MELFA Technical News

Subject Change of appearance of Dummy plug (2D-DP1)

Model SD , F series

Type name : 2D-DP1 (CR1D, CR1DA, CR750, CR760, CR780, 2F-32CONxxM accessories)

Parts	Change before	After change
Dummy plug (2D-DP1)

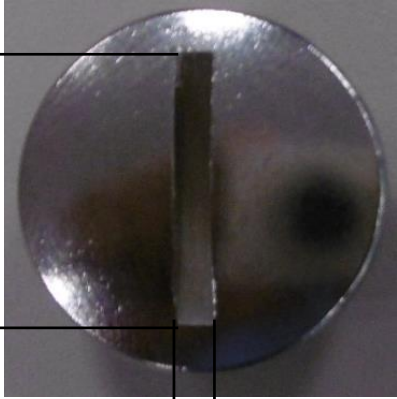
The screw part of upper part of dummy plug (2D-DP1) is changed.

There are no performance of the product and influence on the function withthis change.

■About change of appearance of dummy plug (2D-DP1)

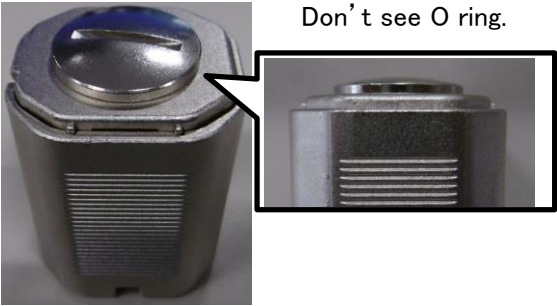
When changing screw part of upper part , the appearance will be changed as follows.

(1) Change of screw head cut-out size.

Screw head cut-out size(Width × Length(mm))	
Change before	After change
<p>Size: 2 × 14.5</p>  <p>14.5</p> <p>2</p>	<p>Size: 2.5 × 12</p>  <p>12</p> <p>2.5</p>

(2) Can see screw part's O ring from the side of dummy plug.

Change before	After change
<p>Don't see O ring.</p> 	<p>O ring Visible.</p>
